NOTICE OF THE MEETING OF THE PLAN COMMISSION

AGENDA FOR REGULAR MEETING VILLAGE OF TINLEY PARK PLAN COMMISSION

**ITEM #1 WORKSHOP/PUBLIC HEARING – BREMEN ANIMAL HOSPITAL ADDITION,
7613 159TH STREET – ARCHITECTURE/SITE PLAN APPROVAL, VARIATION**

PLAN COMMISSION STAFF REPORT

A-0.1

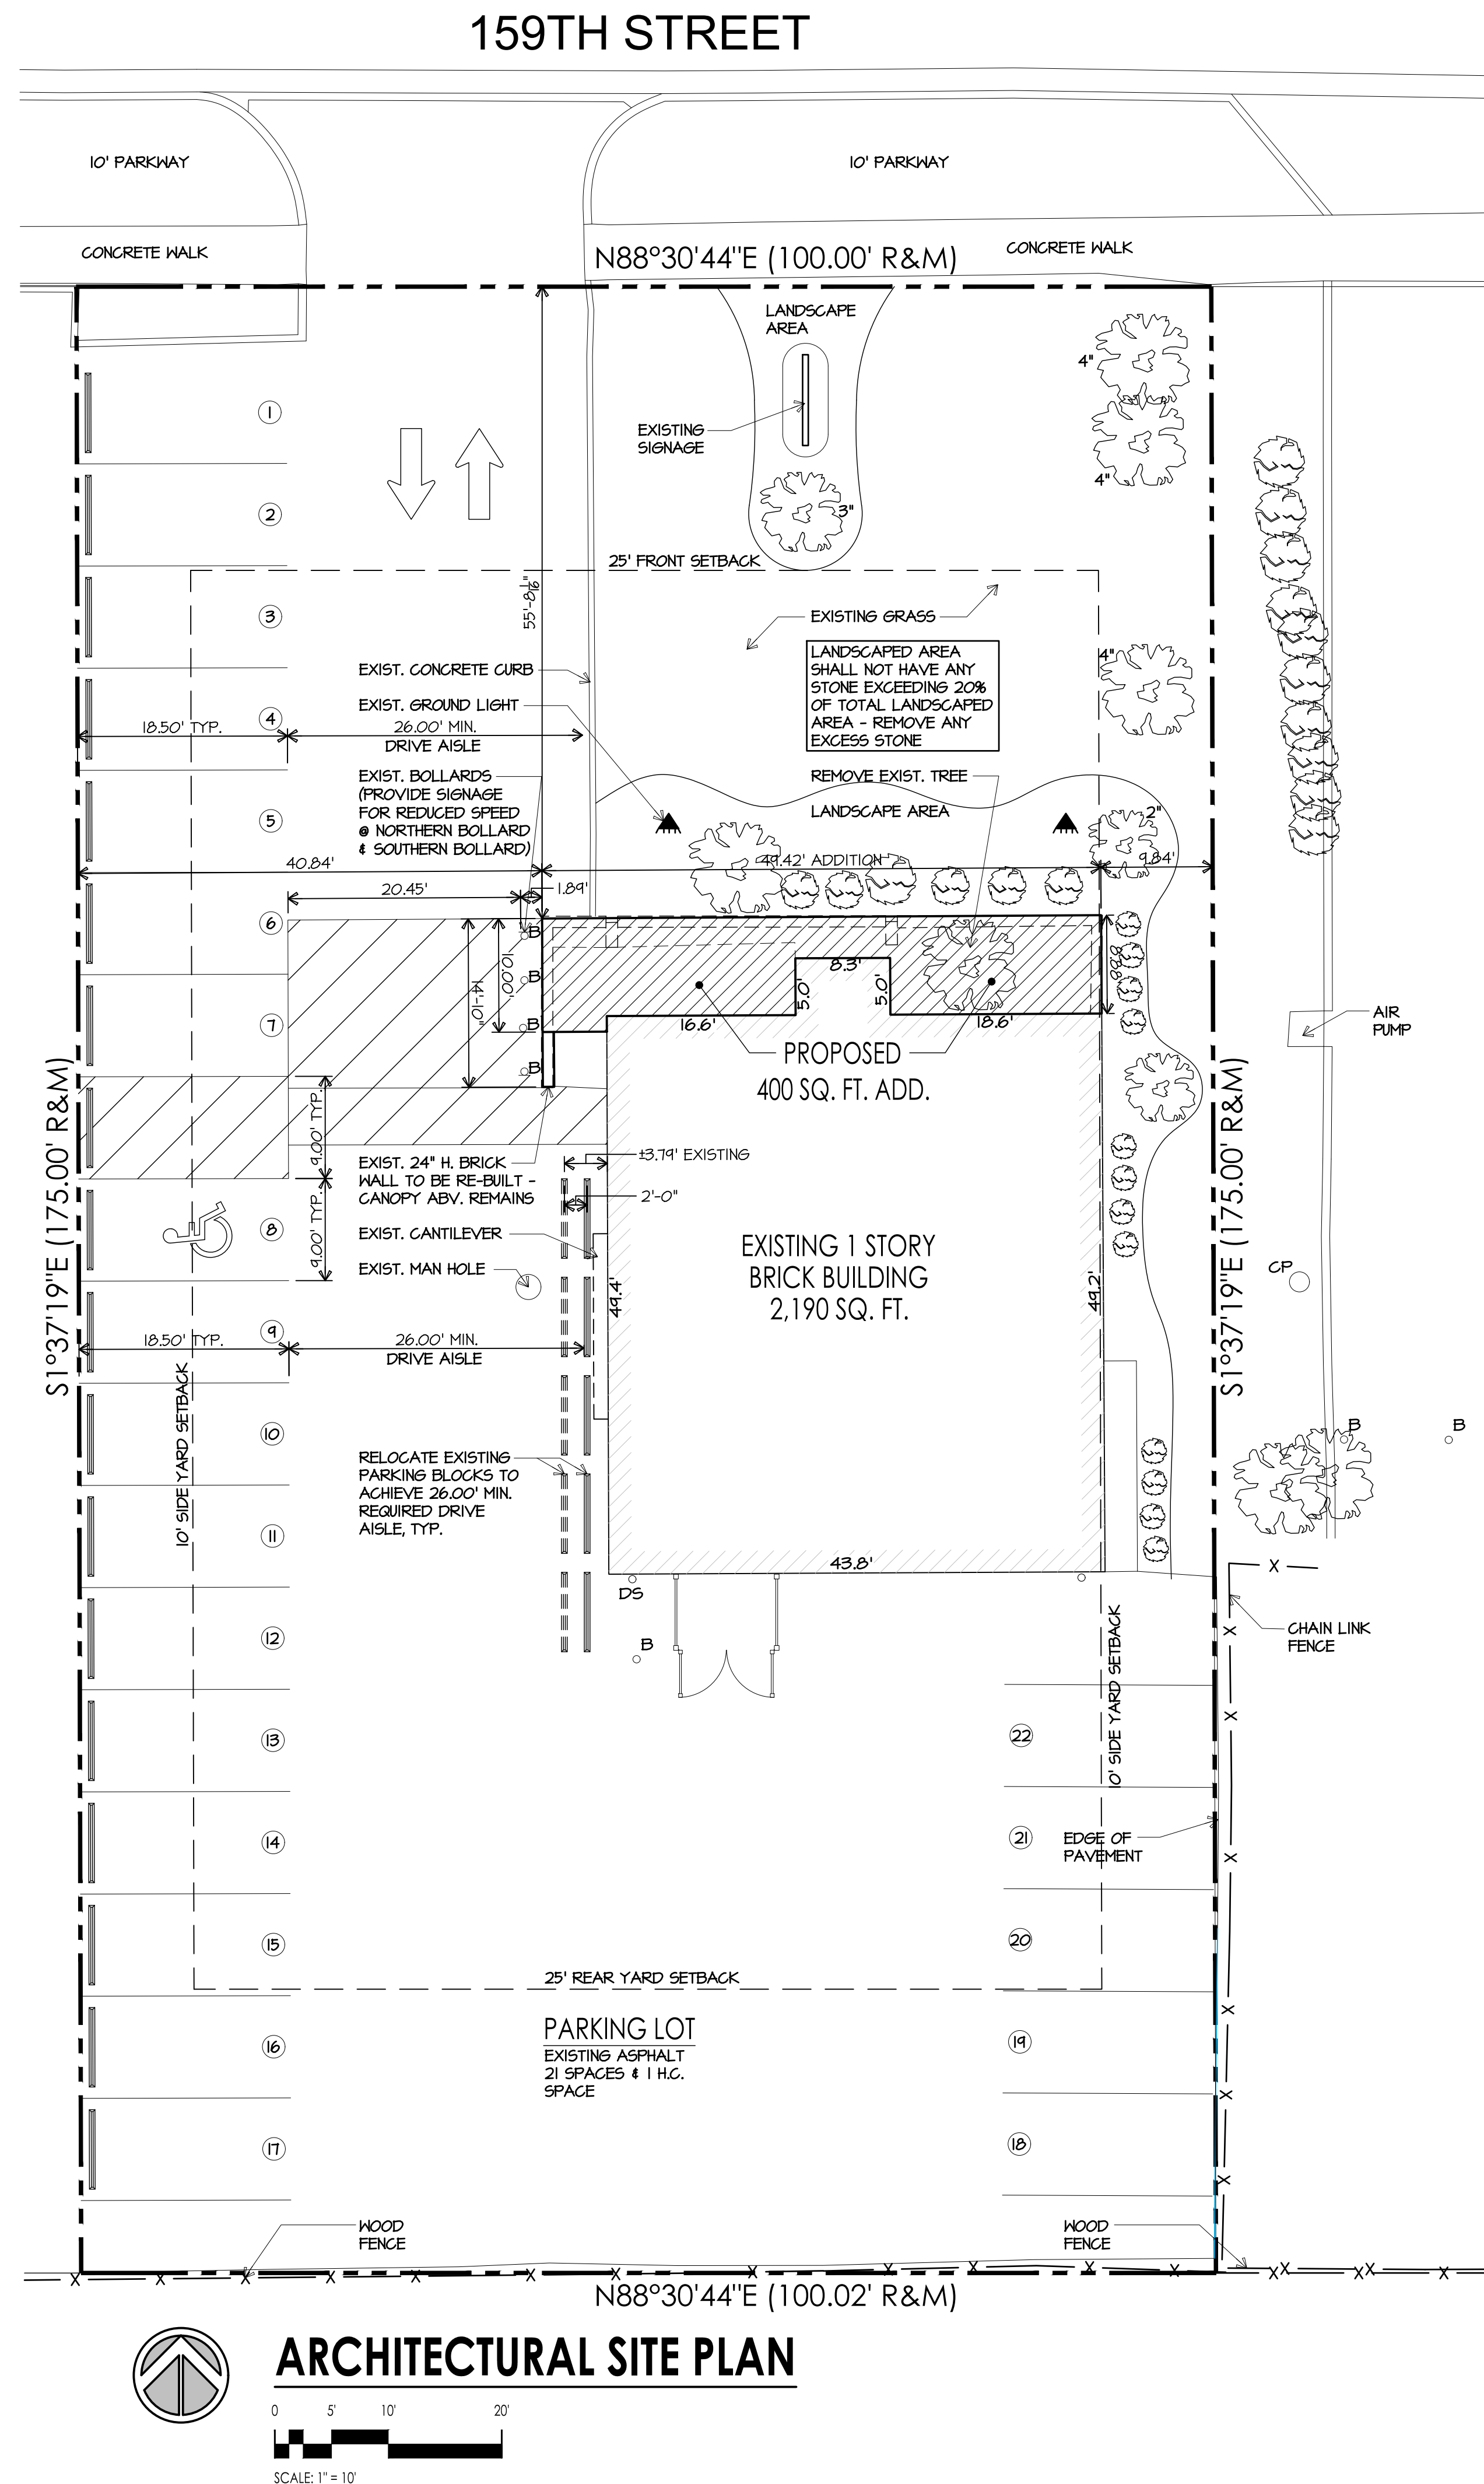
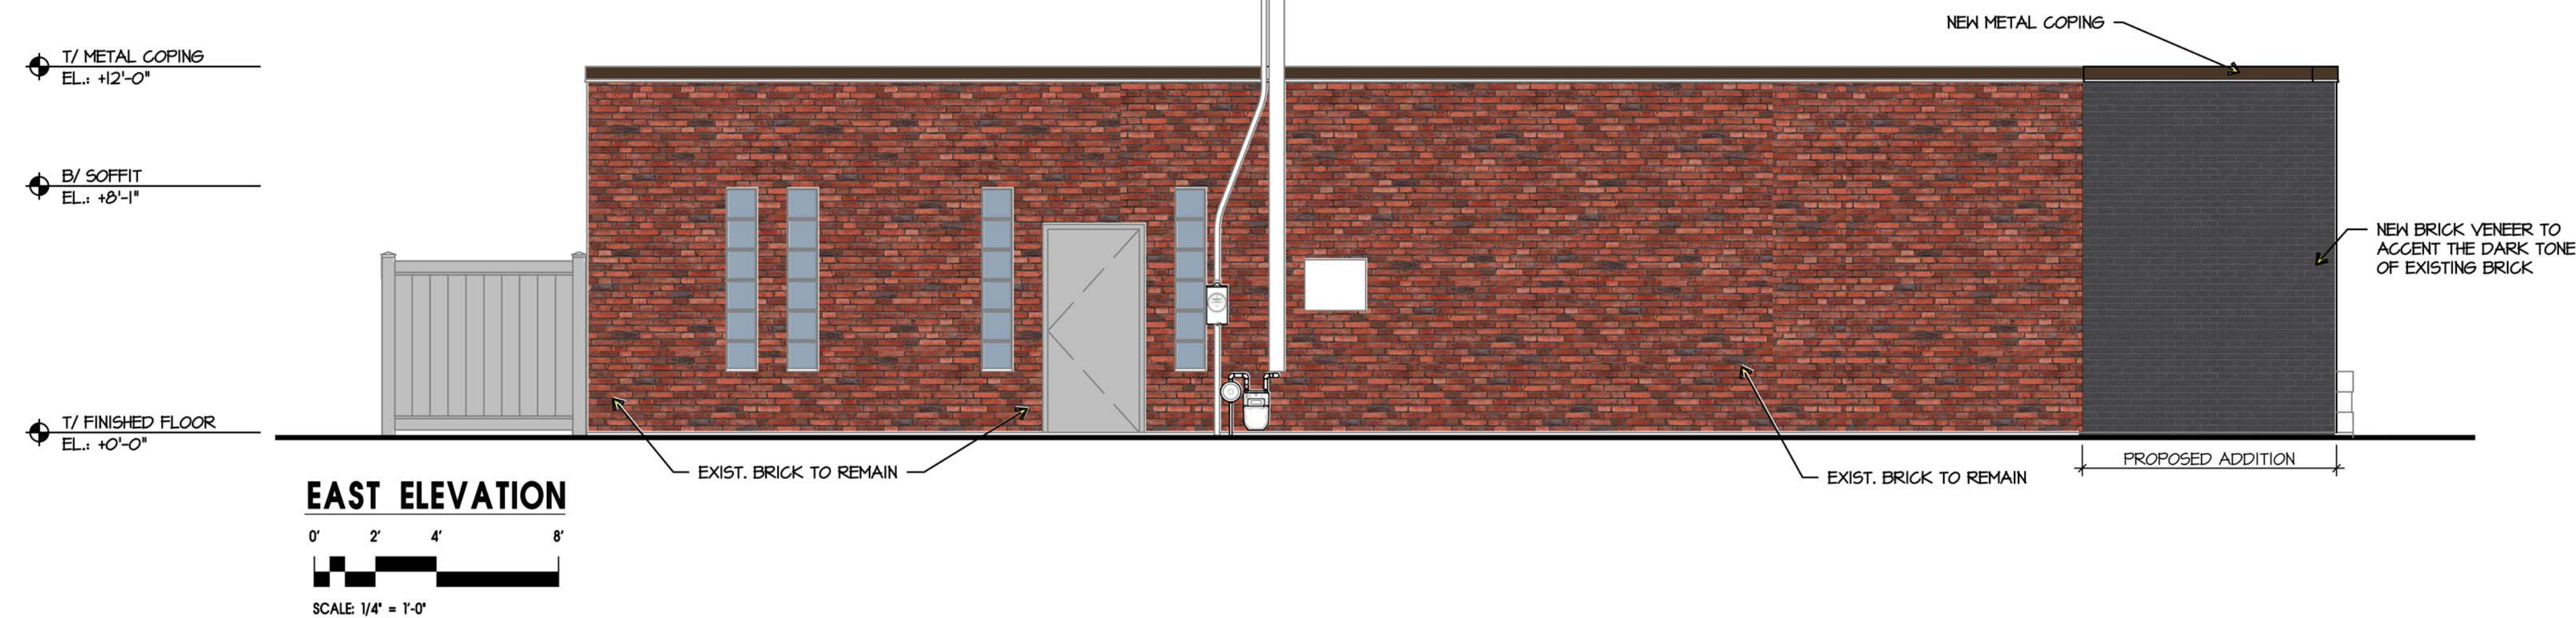
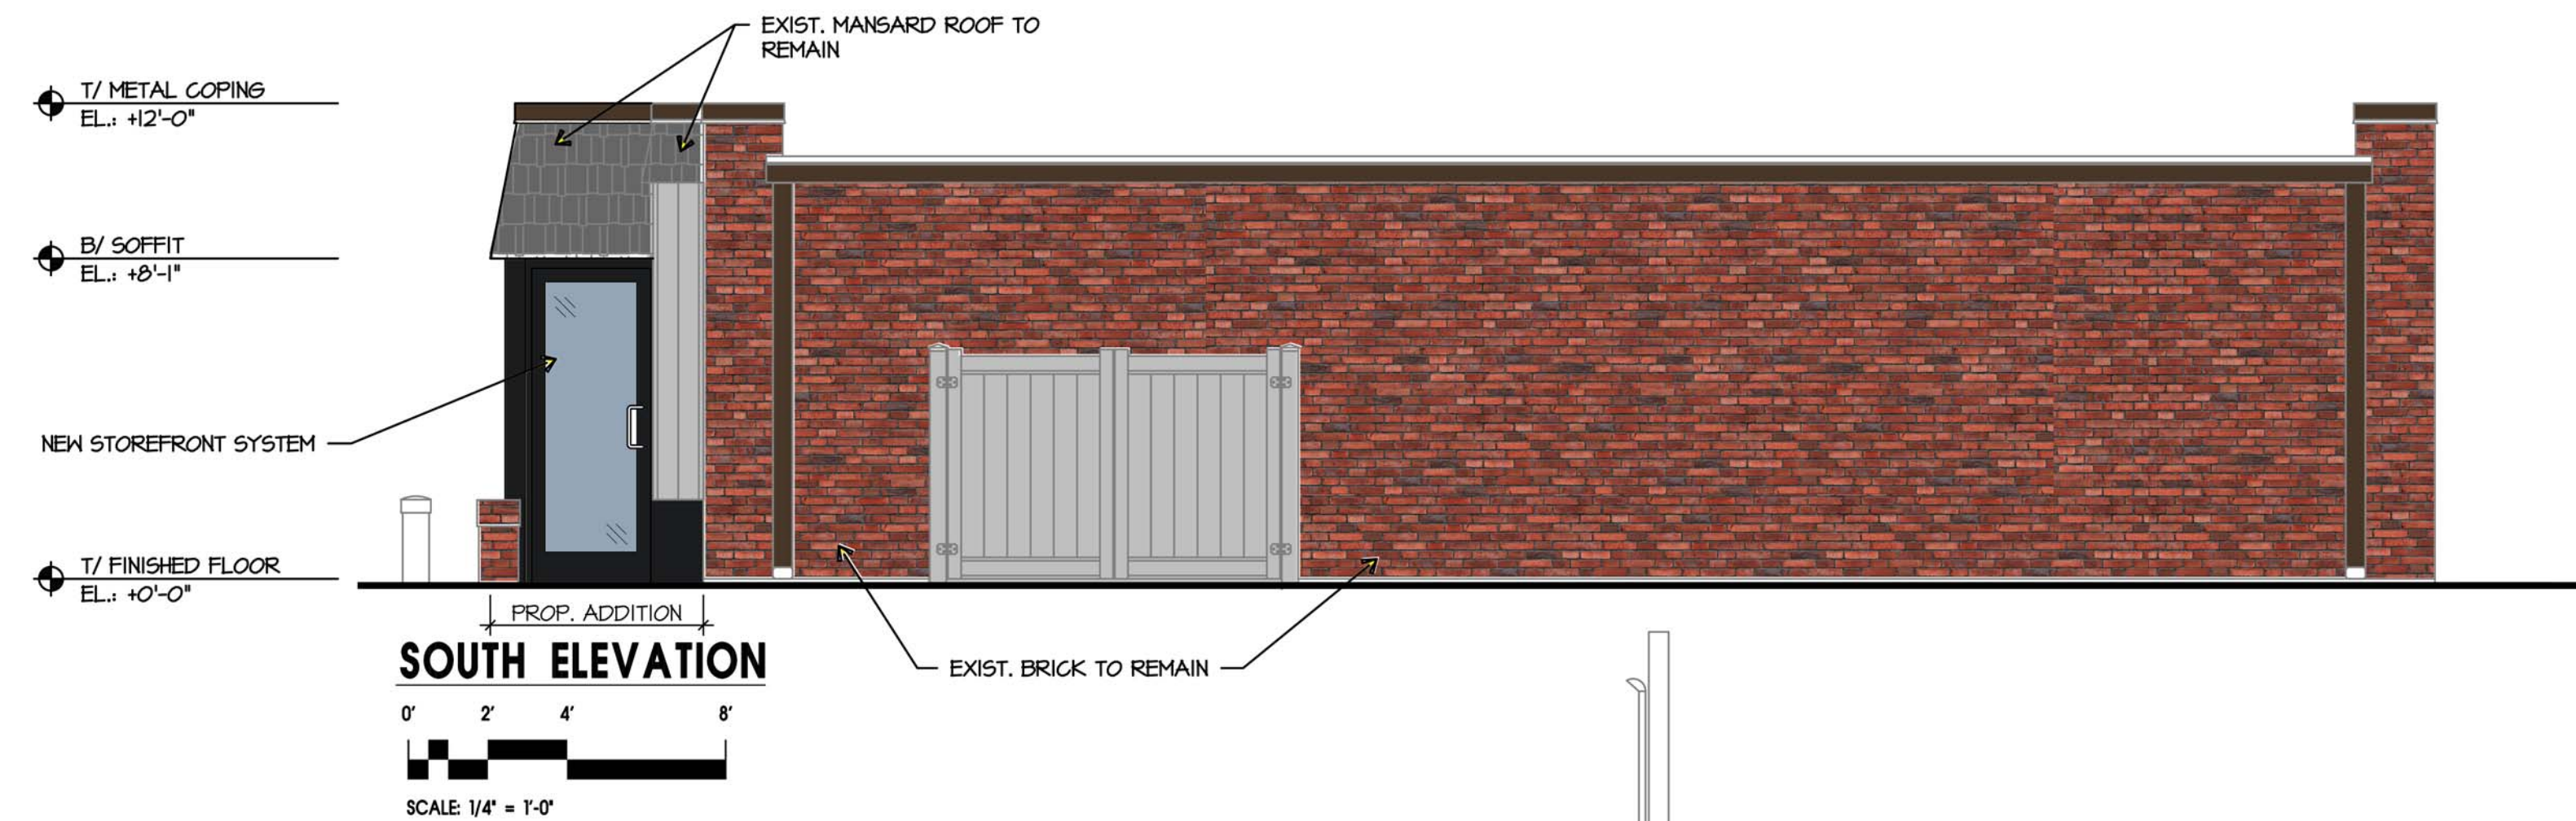
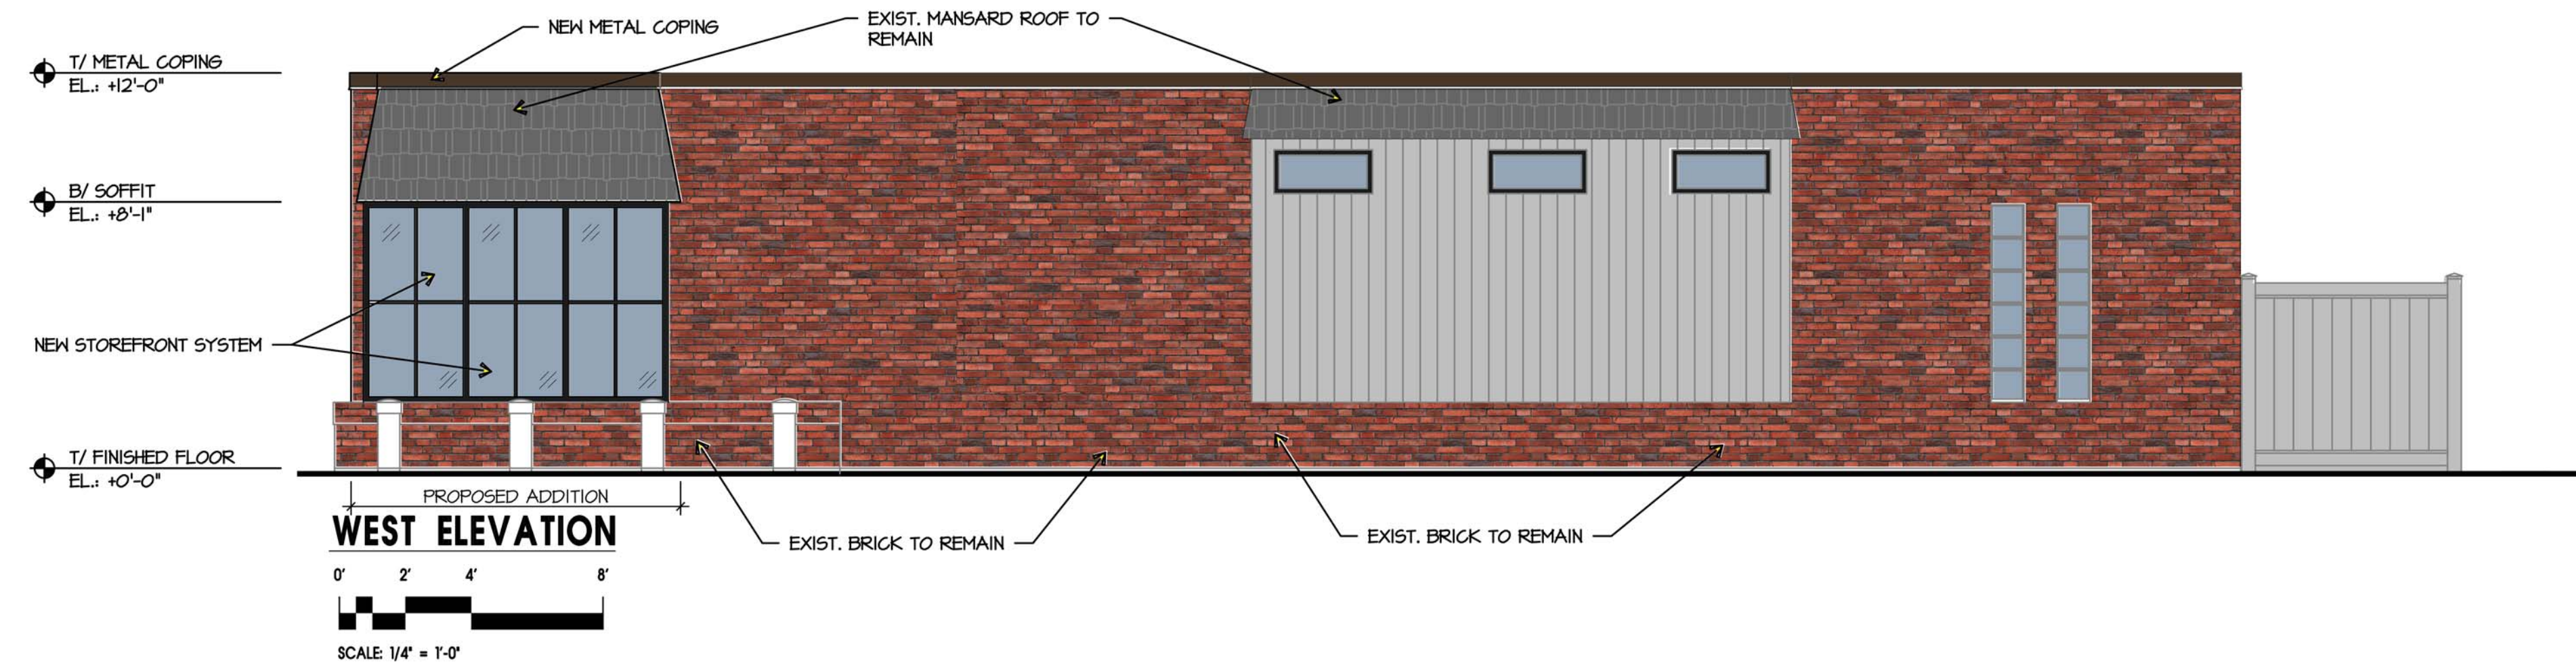
1. There are dimension differences between the plans. Unless directed otherwise we will use the engineer's drawing (Base C1) as having the most accurate dimensions. **Updated architectural site plan to show same dimensions.**

2. On Base C.1- There is a note to remove and replace bollards. Please explain why; are you moving them closer to the building? **The existing bollards are low in height and may not be visible to some drivers, new bollards will be 4'-0" high and painted traffic yellow for high visibility.**

4. What is the distance in a north-south direction of the aisle that is reduced to 20.45'? I want to make the point that this is only a small portion of the drive aisle. Therefore I want to know the area that is 20.45' x ? **The north-south dimension and area has been provided – see site plan.**
